Geotechnical Exploration, Inc.

Job No. 16-11251

Subject: **Response to City of San Diego Cycle Review Comments LDR-Geology: Project No. 508125, Cycle Issue 11**
Proposed Foxhill Residence
7007 Country Club Drive
La Jolla, California

CROSS SECTION D-D'

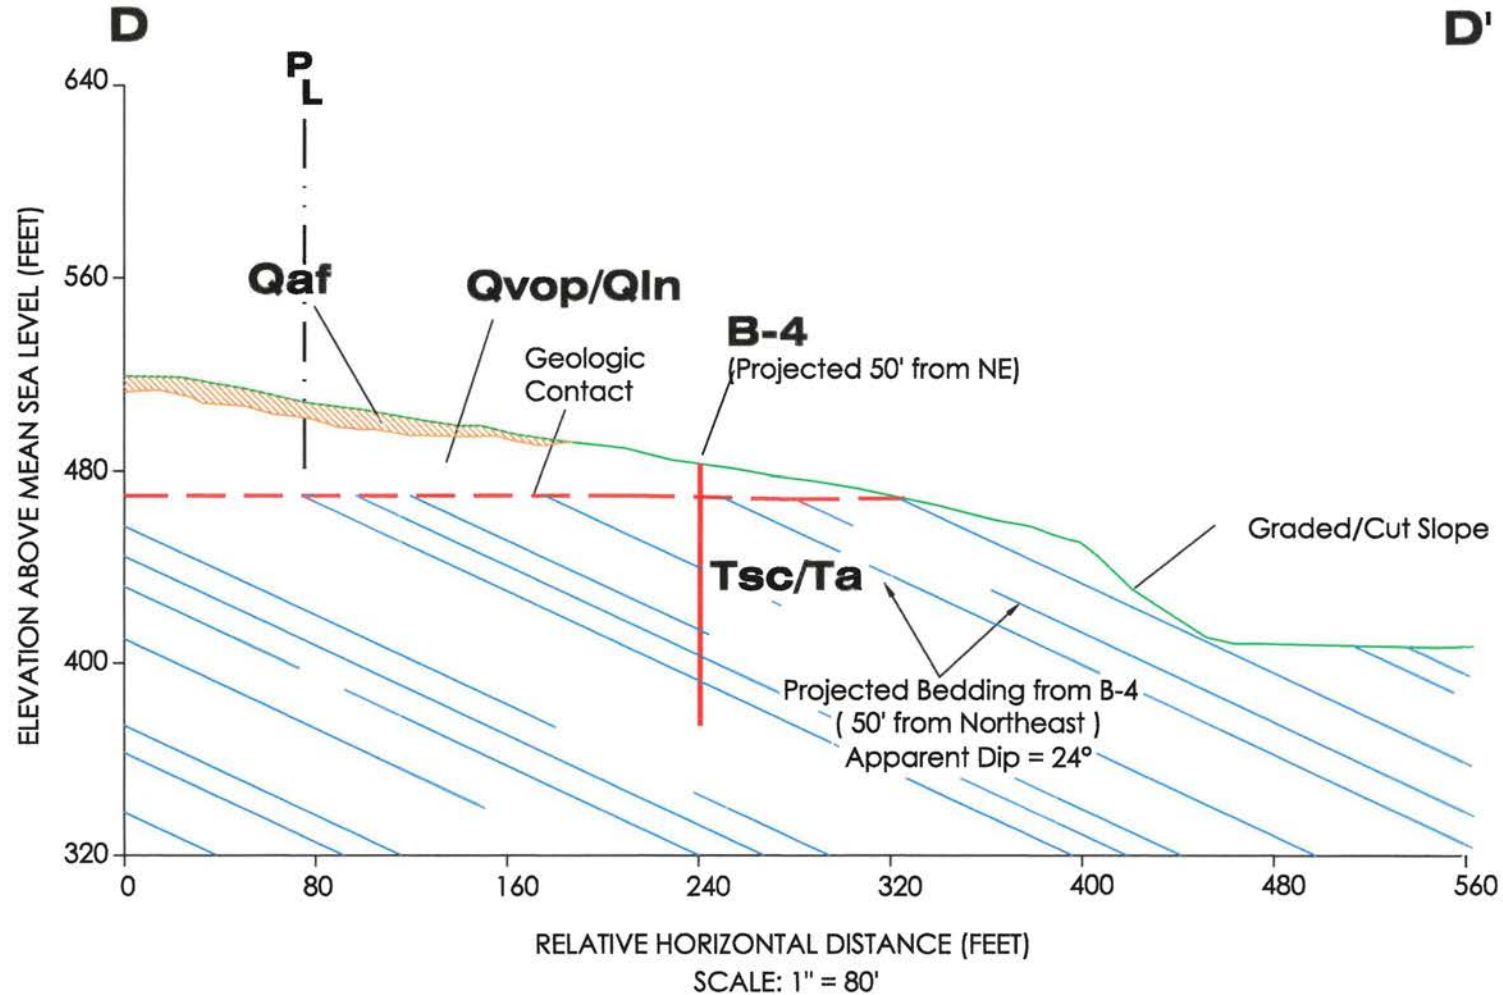
Issue No. 5: Provide geologic/geotechnical cross-sections representative of the site conditions and proposed grading. (Outstanding Issue from Cycle 2)

GEI Response: We have included geologic/geotechnical cross-sections representative of the site conditions and proposed grading from the referenced architectural and grading plans with this update letter as Figure Nos. IIa-b. In addition, we have included a revised geologic cross-section D-D' from our "Report of Preliminary Geotechnical and Geologic Investigation, Copley Press Residential Project," dated November 16, 2011, of the adjacent parcel (APN 352-300-04-00) and a portion of the subject site. Please, refer to Figure Nos. Ia-b for the geologic cross-section locations on the Plot Plans with Site-Specific Geology. Refer to Figure No. IIc for the revised Geologic Cross-Section D-D'.

*Excerpt from Geologic Hazards Map-
Sheet 29*

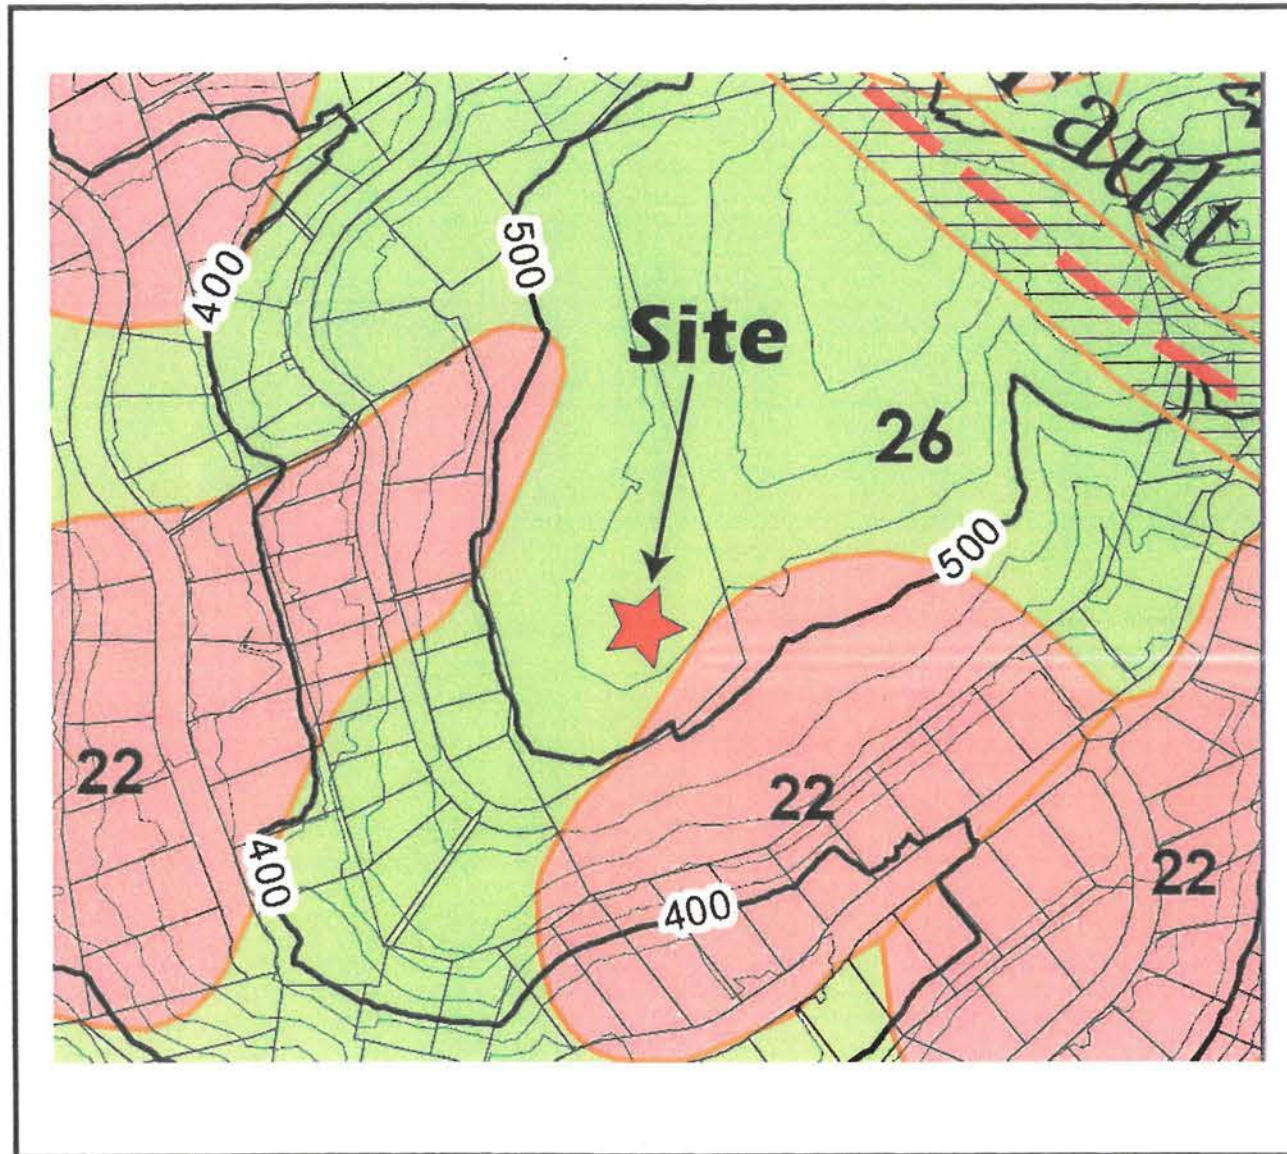
Issue No. 6: According to the San Diego Seismic Safety Study Geologic Hazard Maps, a portion of the access road for the guesthouse is located in geologic hazard category 22, indicating potential slope instability, possible or conjectured landslide. Clarify if the site or any portion of the site is located on or adjacent to a landslide. Provide the rationale and site-specific physical evidence used to support a determination regarding the presence or absence of landsliding at the site. (Outstanding Issue from Cycle 2)

GEI Response: We understand a portion of the proposed access road for the residence is located in Geologic Hazard Category (GHC) Zone 22. Based upon our recent and previous site exploration, downhole logging of a large diameter boring for our "Report of Preliminary Geotechnical and Geologic Investigation," dated November 16, 2011 (adjacent parcel), our geologic traverse across the site, review of the geologic map (Kennedy and Tan, 2008), review of the referenced City of San Diego Seismic Safety Study -- Geologic Hazards Map Sheet 29 and stereo-pair aerial photographs (4-11-53, AXN-8M-1 and 2), there are no known or suspected ancient landslides in the vicinity of the subject site. Please, refer to Appendix A for the Geologic Hazards Map and Legend.

Project		FOXHILL ESTATES	
Analysis Description		GLOBAL SLOPE STABILITY	
Drawn By	R.A.C.	Scale	1:450
		Company	G.E.I.
Date	3/5/2020, 7:27:38 AM		File Name
			JOB NO. 16-11251_S(B)_01.slim

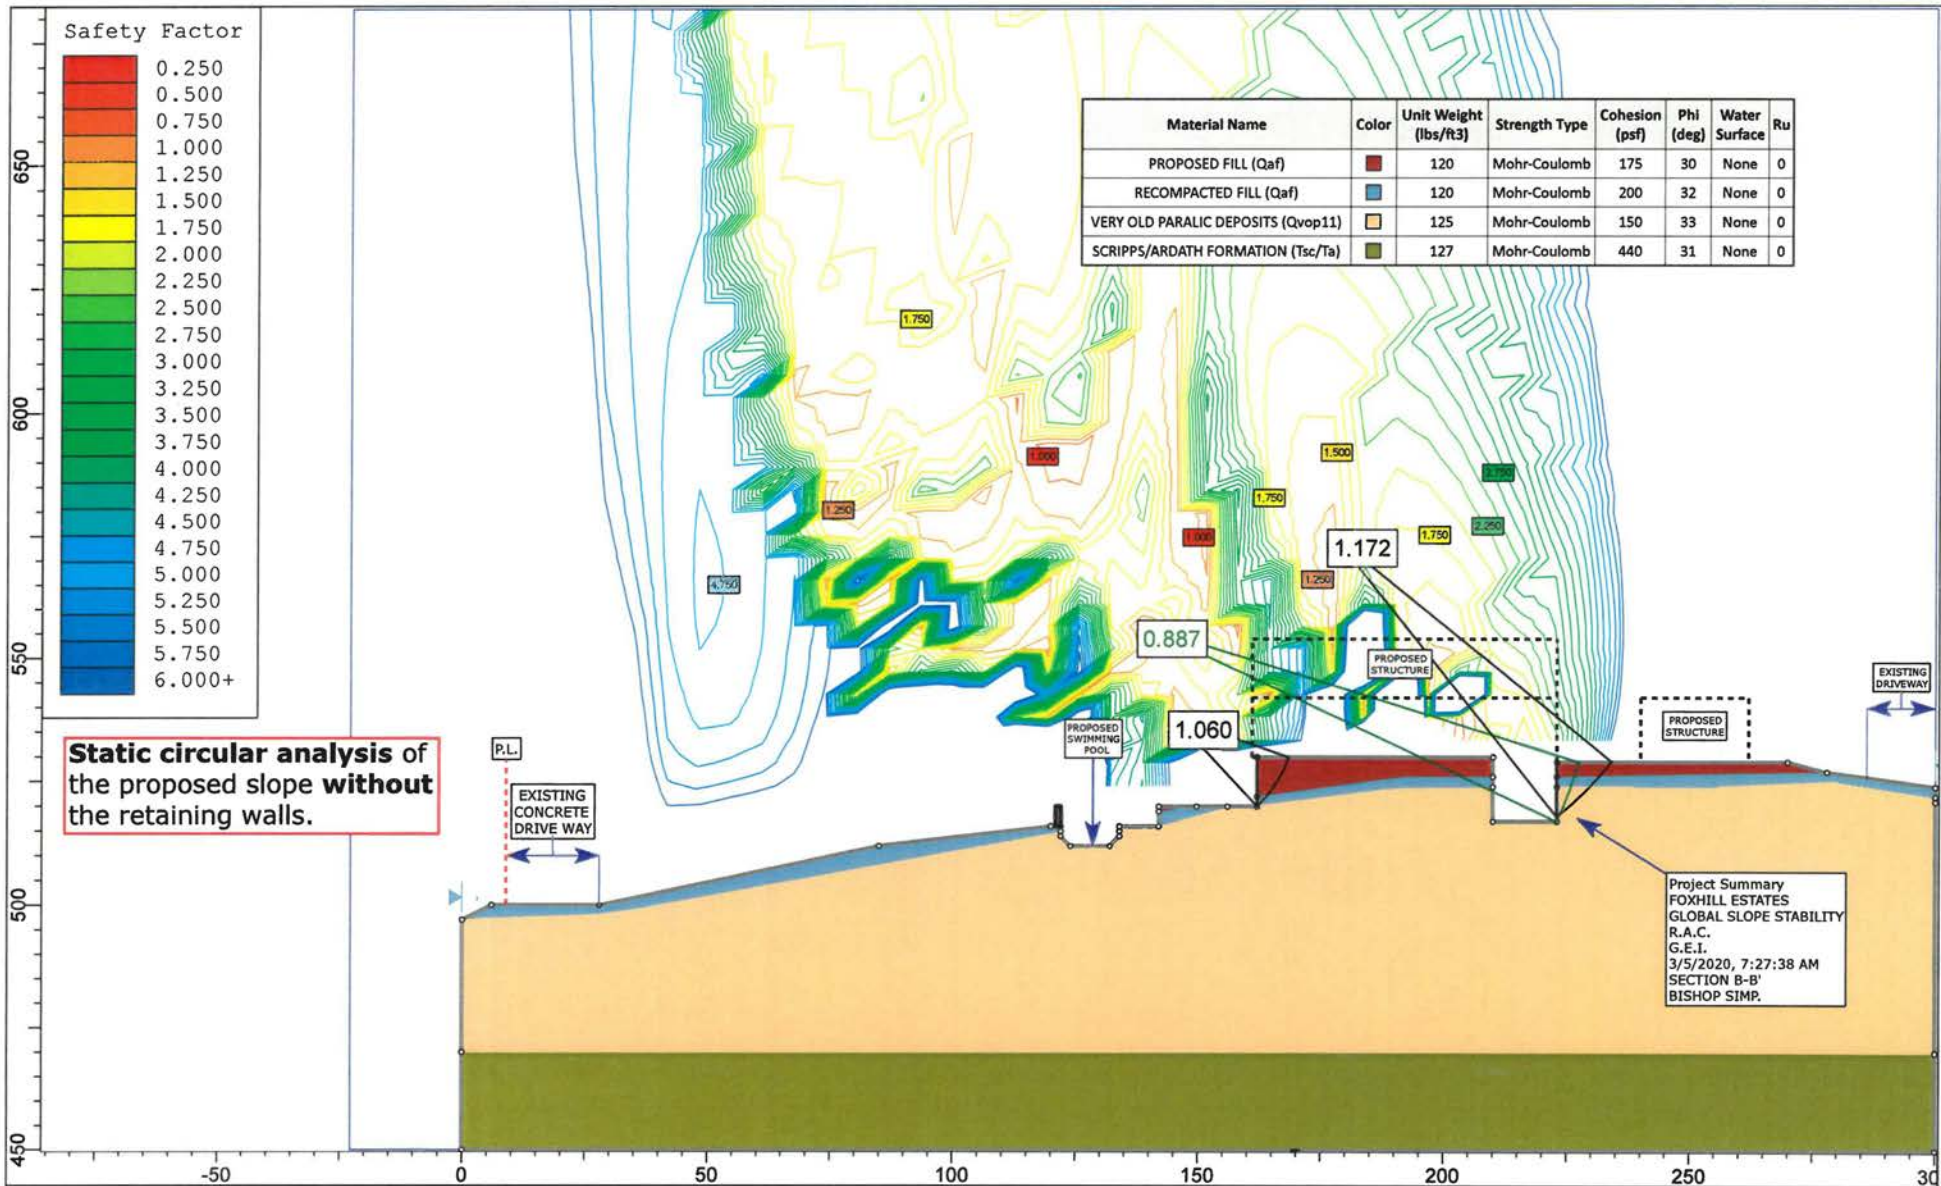
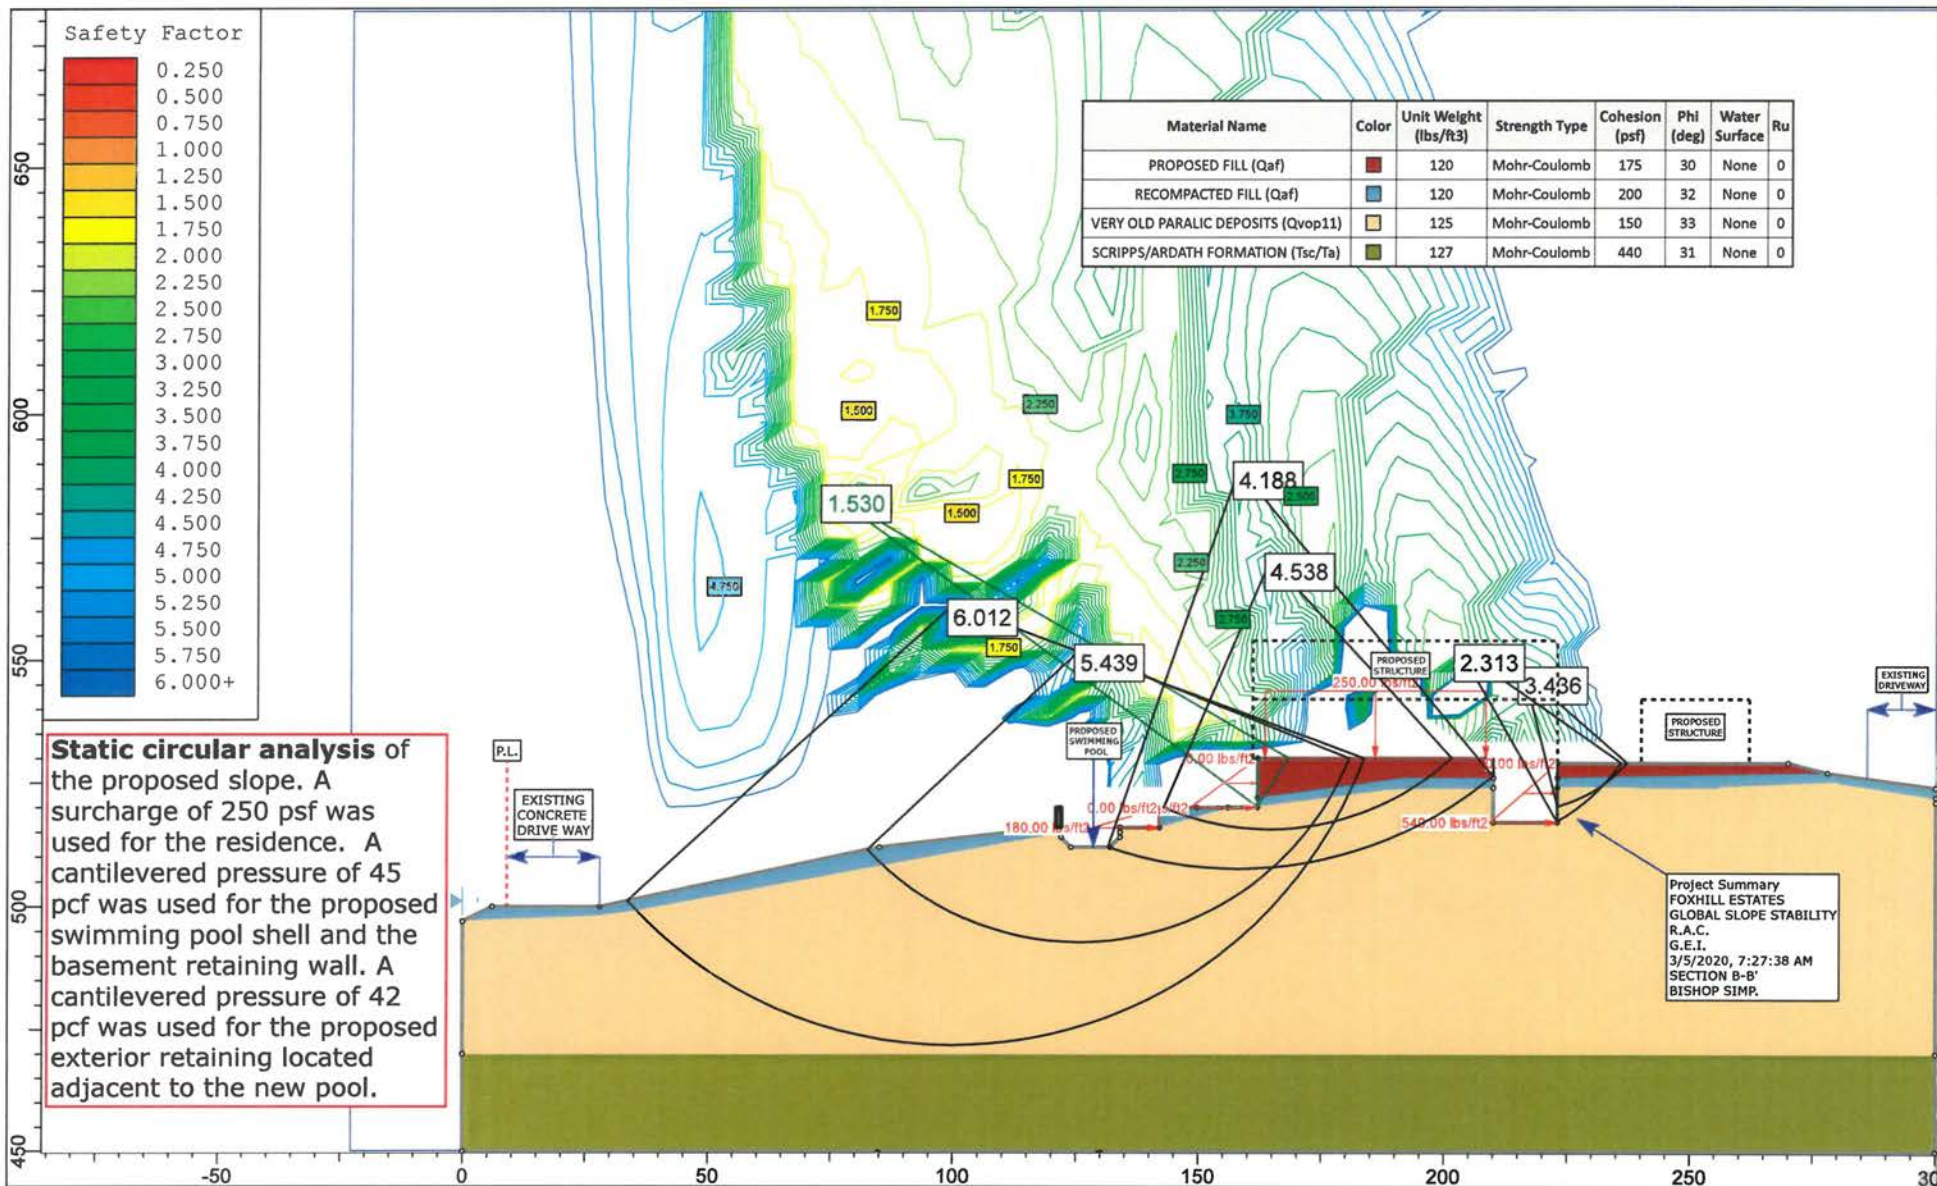
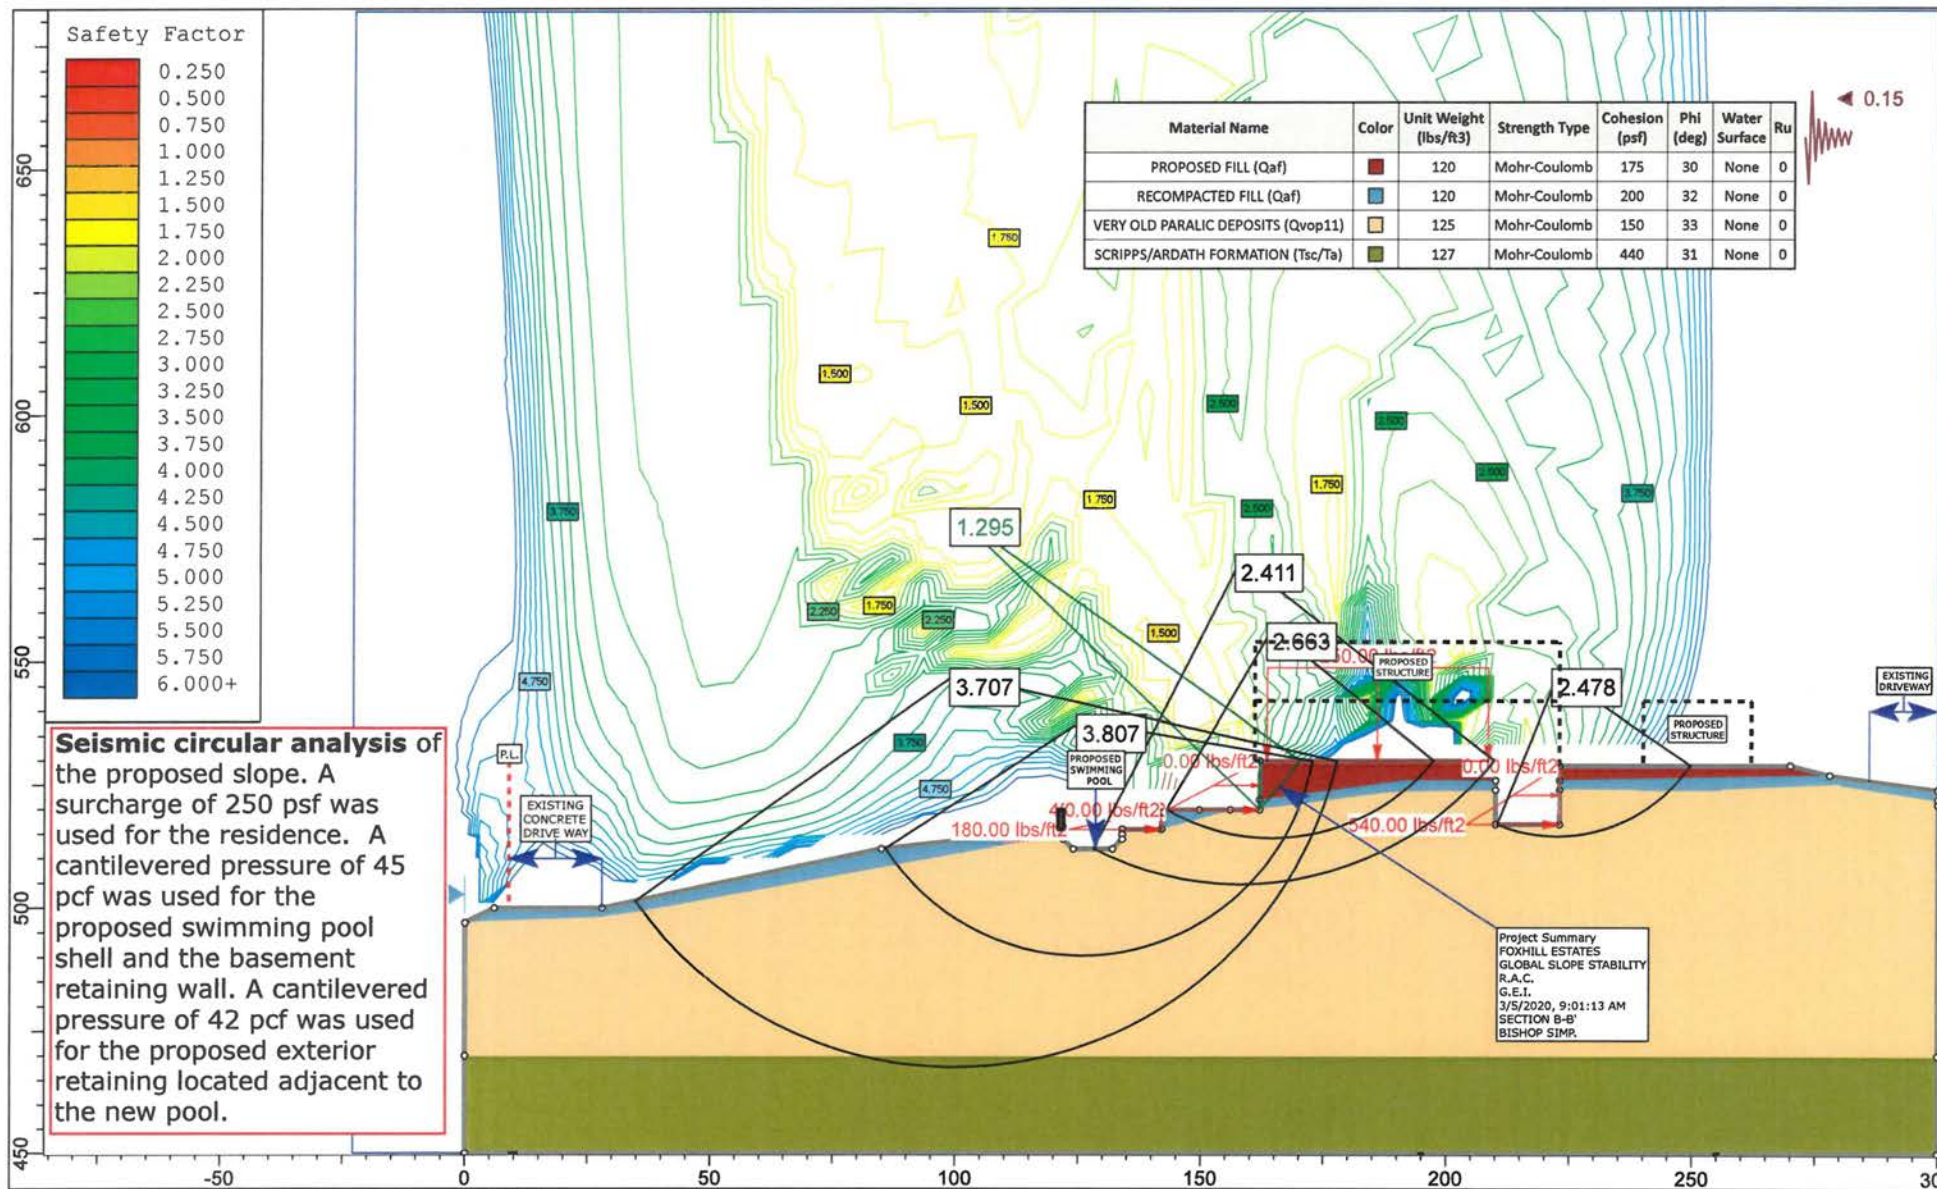
Issue No. 7: *The project's geotechnical consultant must provide a professional opinion that the site will have a factor-of-safety of 1.5 or greater, for both gross and surficial, following project completion. (Outstanding Issue from Cycle 2)*

GEI Response: Attached to this addendum update letter are the slope stability calculations addressing the global and surficial stability after the completion of the proposed development. We performed global and surficial stability along geologic cross-section B-B'. Refer to Appendix C for slope stability calculations. The global stability yielded a factor of safety of 1.5 or greater for static conditions, and a factor of safety of 1.5 or greater under seismic conditions. Surficial failure analysis yielded a factor of safety greater than 1.5. Please, refer to Figure Nos. Ia-b for the geologic cross-section locations on the Plot Plans with Site-Specific Geology. Refer to Figure Nos. IIa-c for Geologic Cross-Sections.

The static gross stability factors of safety were calculated and yielded a factor of safety value above 1.5 and greater with the inclusion of the basement retaining wall.

For section B-B, the analysis consisted of analyzing the existing slope excluding and including the retaining walls. In the analysis which include the retaining walls, a surcharge of 250 psf was applied to simulate the load of the building. A cantilevered equivalent lateral fluid pressure of 45 pcf was applied to the swimming pool shell and basement retaining wall, and a cantilevered pressure of 42 pcf was applied to the exterior retaining located adjacent to the swimming pool.

Once the static gross stability was determined for each section, a seismic analysis was performed for the same analyzed sections. The seismic analysis yielded a factor of safety value above 1.15 as required by the City of San Diego and the State of California.
